CITY OF VALDEZ
Project Title: New Well 5 Pumping Station
Project No.: 21-310-2538
Contract No.: 2406

TO: All Recipients
SUBJECT: Addendum No.5

Date: November 12, 2025

VALDEZ WELL HOUSE #5 QUESTIONS AND ANSWERS

TITLE	BUILDING PIPING PLAN AND SECTION
PROJECT	NEW WELL 5 PUMPING STATION VALDEZ, ALASKA

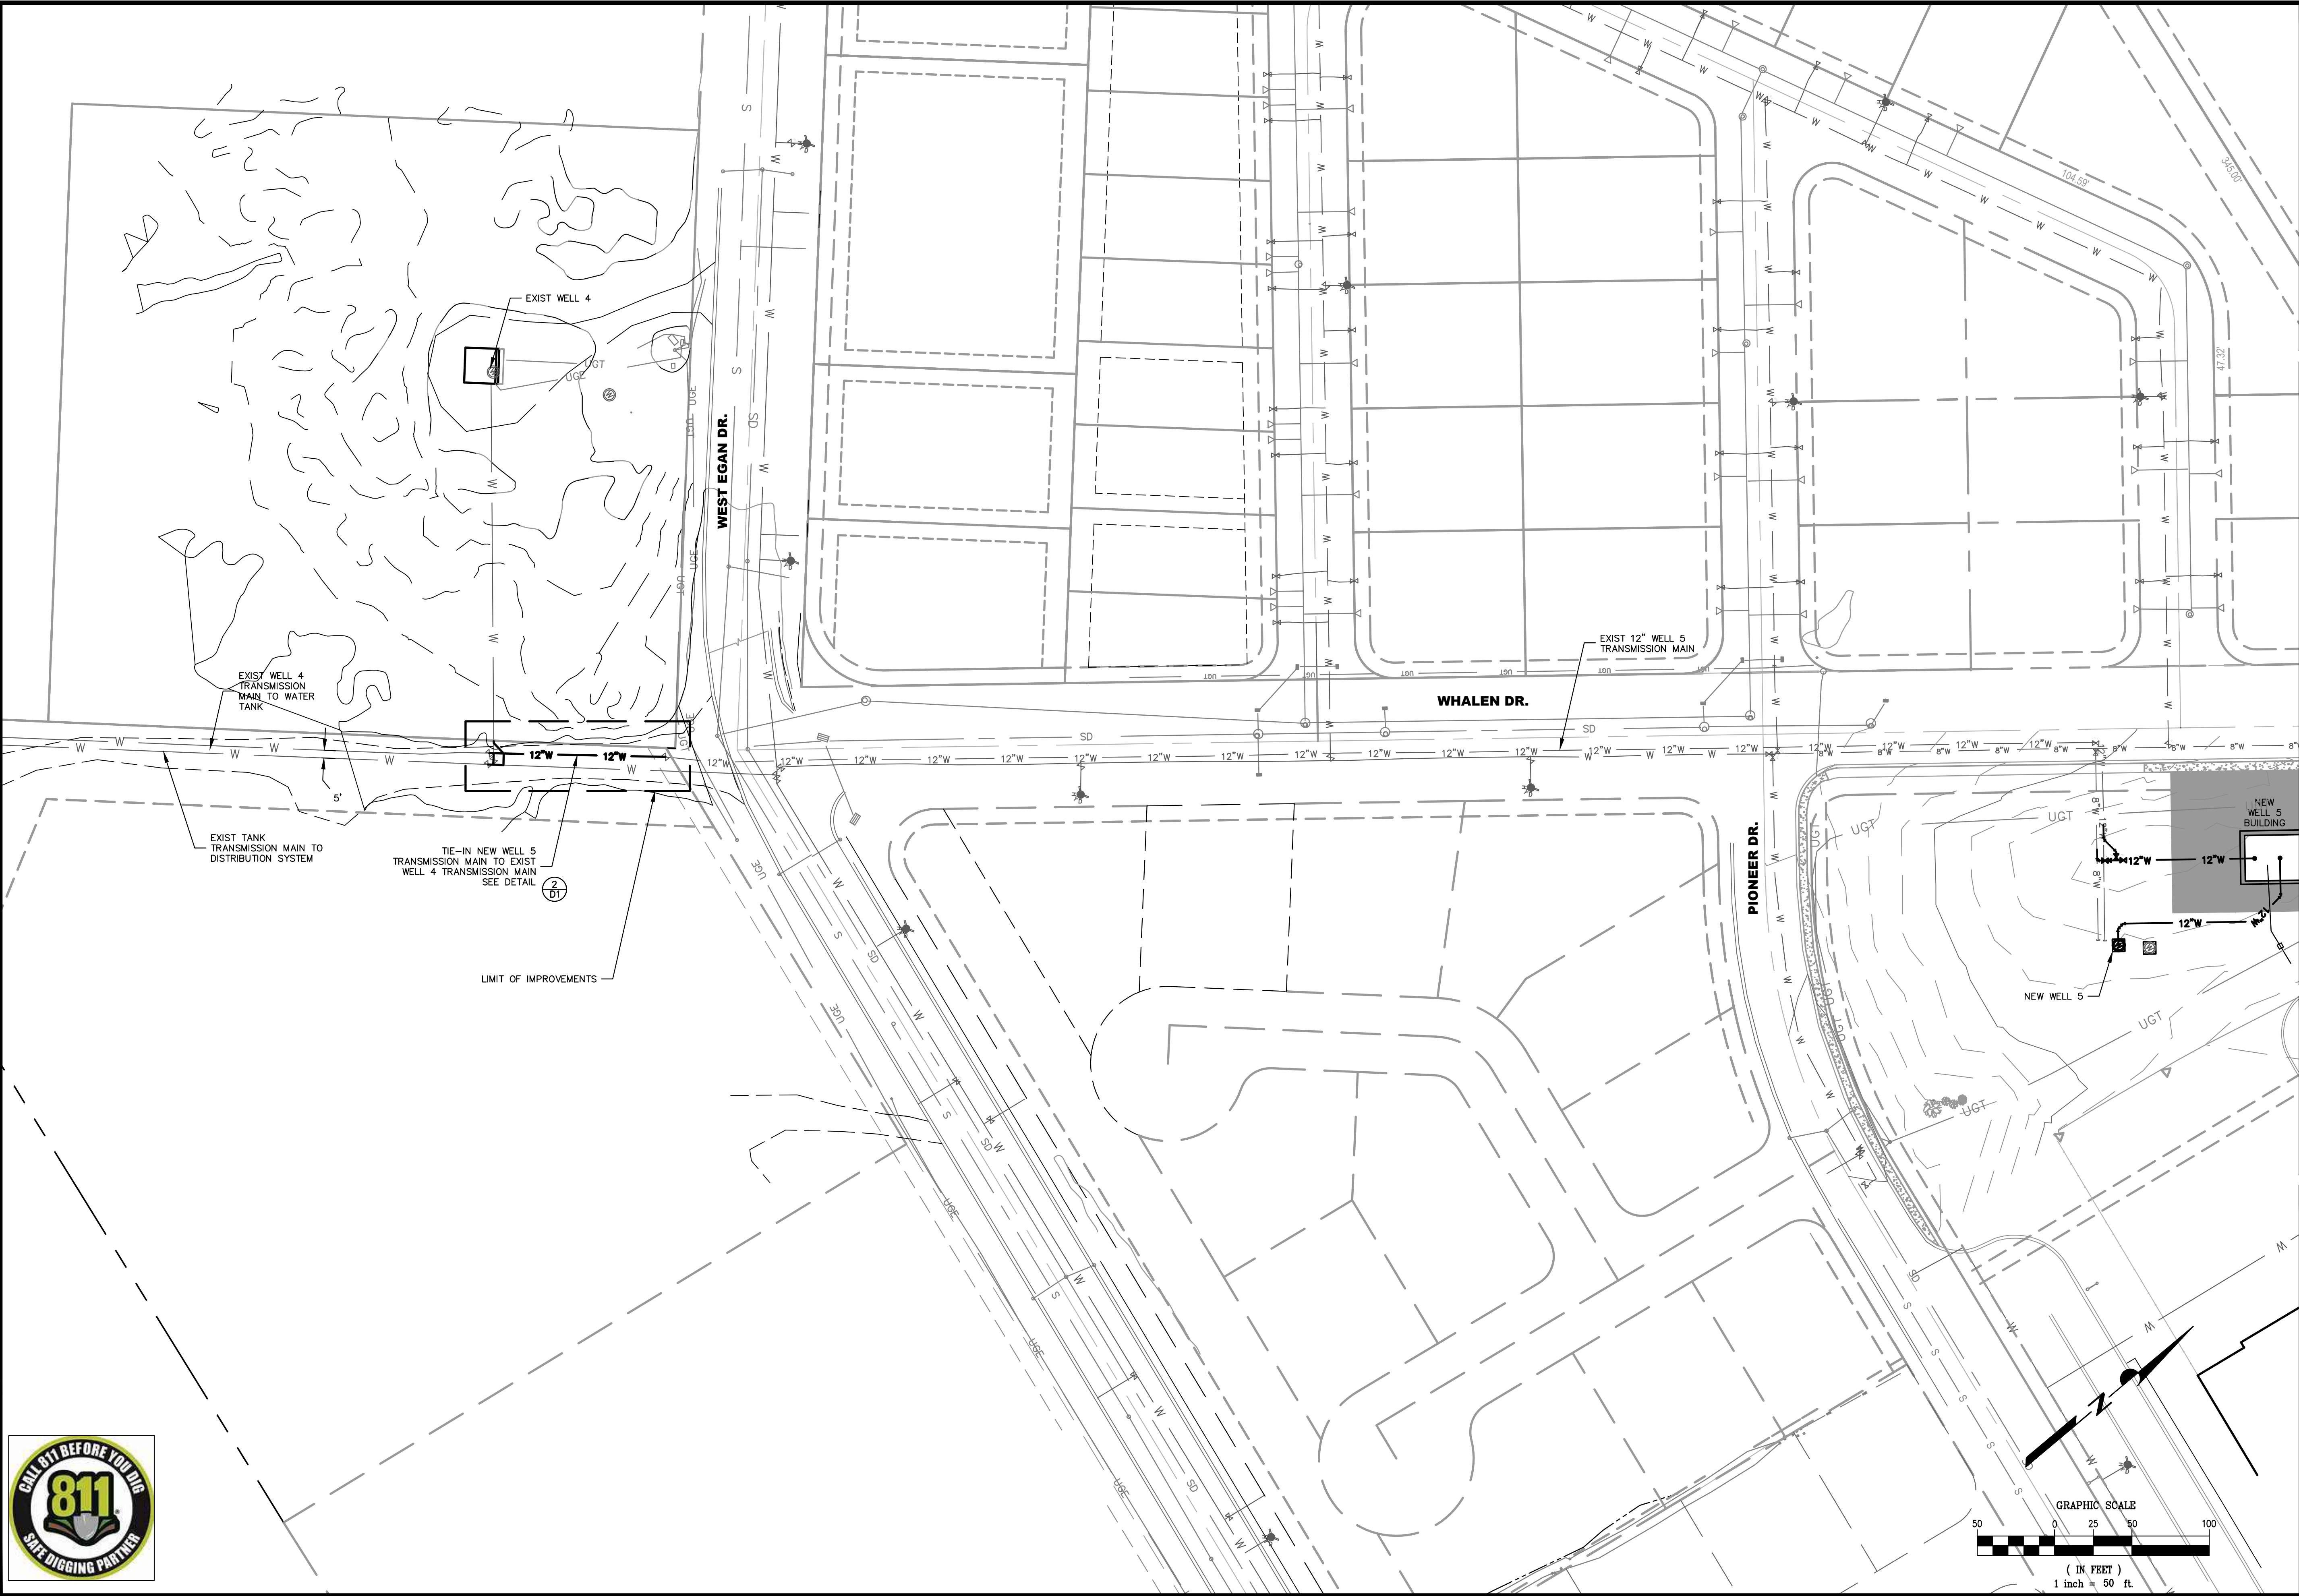
10. **Question:** The plans are vague regarding I.E., of the new or existing piping. If available, can you please provide the elevations of the existing waterlines or as-builts?

Answer: See attached proposed and existing pipe elevations on the revised plans. The elevations are clouded on sheets C5, C8 and D1.
